RA4M2 Group

Evaluation Kit for RA4M2 Microcontroller Group
EK-RA4M2 v1
Errata

Renesas RA Family
RA4 Series

Figure 1. USB FS Series Resistors R21, R22

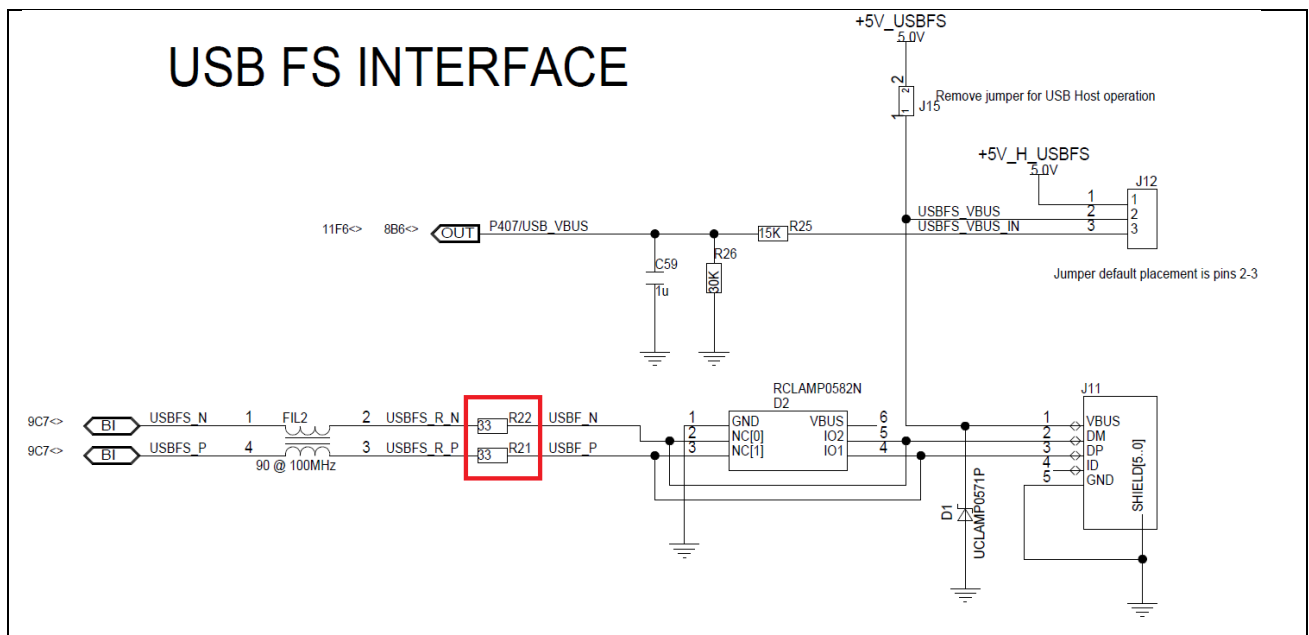
According to the following section in the *RA4M2 Hardware User's Manual*, r01uh0892ej0101-ra4m2.pdf; **26.3.1.4 USB 2.0 Full-Speed Module (USBFS): Example external connection circuits**, the series resistors R21 and R22 in the USB FS interface should have a value of 27 Ω. On affected boards R21 and R22 are fitted with 33 Ω resistors. The EK-RA4M2 v1 schematic reflects these incorrect values as can be seen in Figure 1.

This kit has been confirmed to work with 33 Ω resistors so there is no need to replace them with 27 Ω resistors.

However, in your circuit design, be sure to insert a 27 Ω resistor into the USB differential line to satisfy the characteristics of the USB module.

None. The resistors R21 and R22 have the correct value of 27 Ω on later builds of the board. The schematic has been updated to show the corrected values.
